STAFF REPORT

Review of Silicon Valley Power 2023 Integrated Resource Plan

September 2025 | CEC-200-2025-022

Figure 2: SVP Preferred Portfolio Forecast for Annual Electricity Demand

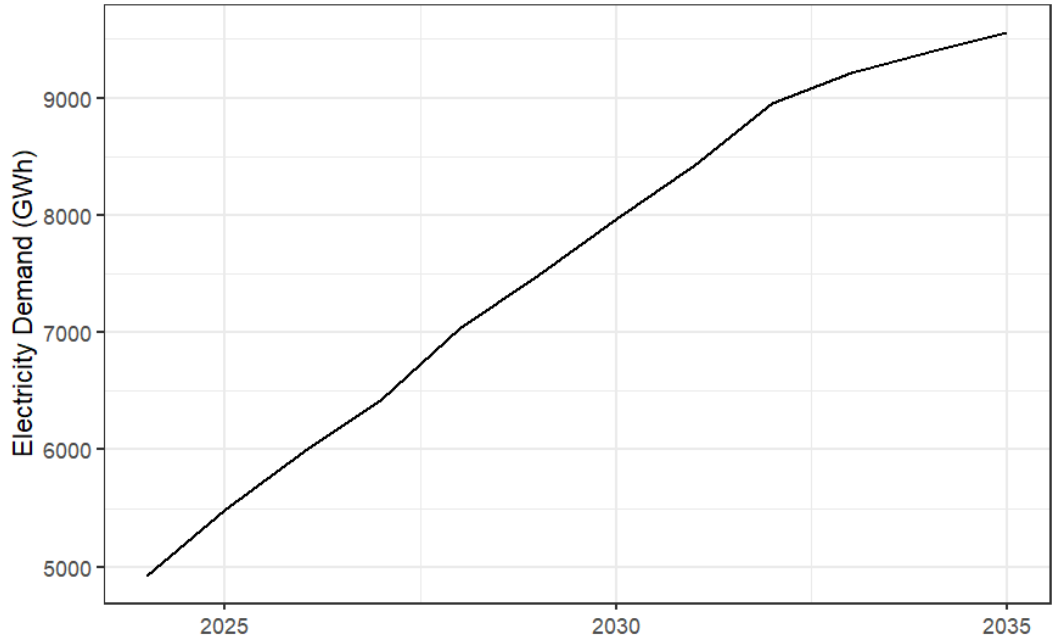
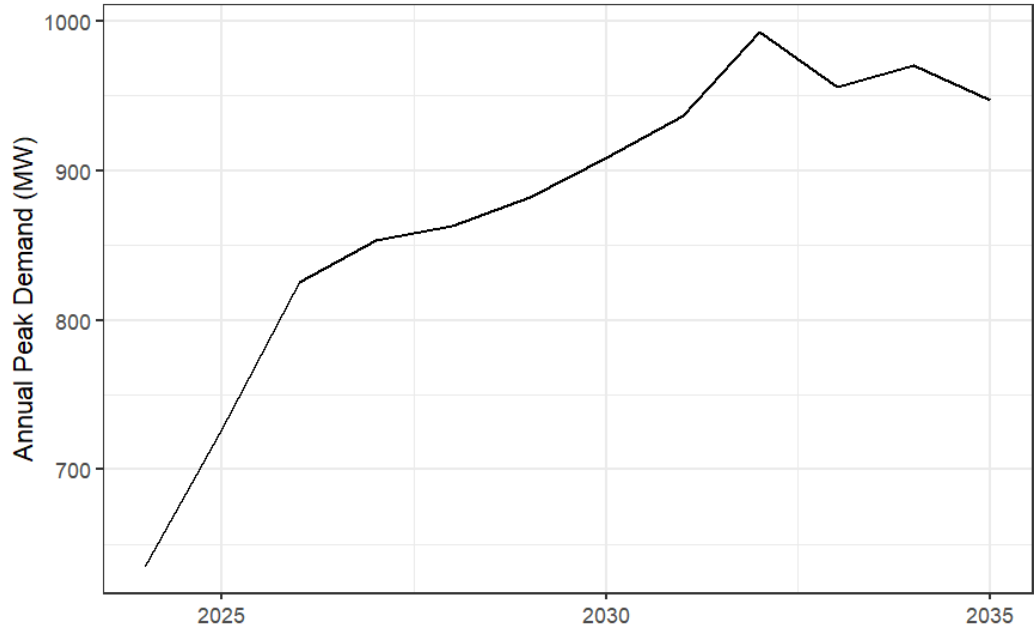
CEC staff compared SVP’s energy and peak demand forecast to the Energy Commission’s 2023 Demand Forecast Update report. The SVP forecast shows one to eleven percent less energy demand as compared to the Energy Commission Forecast Update, each year between 2024 and 2035, which is within the CEC guidelines acceptable range.

Figure 4: Modeled Impact of Resource Portfolios on Retail Electricity Rate

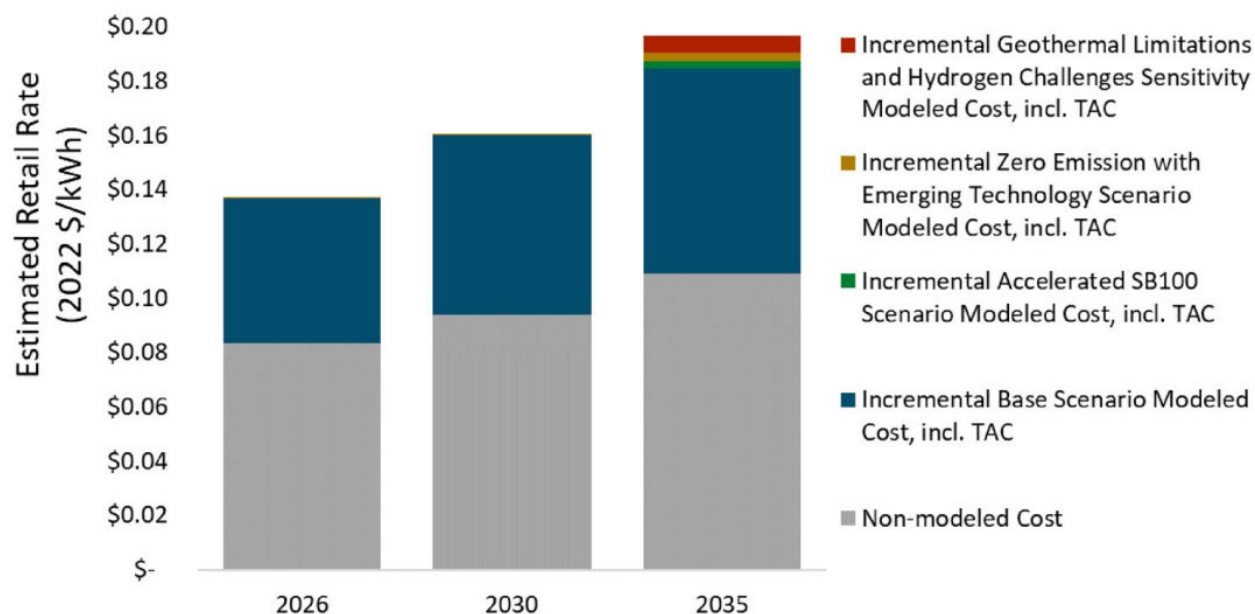
Figure 4 illustrates the retail electricity rates customers will pay, according to capacity expansion modeling, if SVP procures various resource portfolios. The preferred resource portfolio is called Accelerated SB 100 and is represented in green. The sum of the grey, blue, and green segments represents the predicted retail rates if SVP procures the preferred resource portfolio. SVP's capacity expansion modeling estimates that, if the utility implements the preferred resource portfolio, its retail rates will be roughly \$0.14 per kWh (in 2022 dollars) in 2026, \$0.16 per kWh in 2030, and \$0.187 per kWh in 2035.
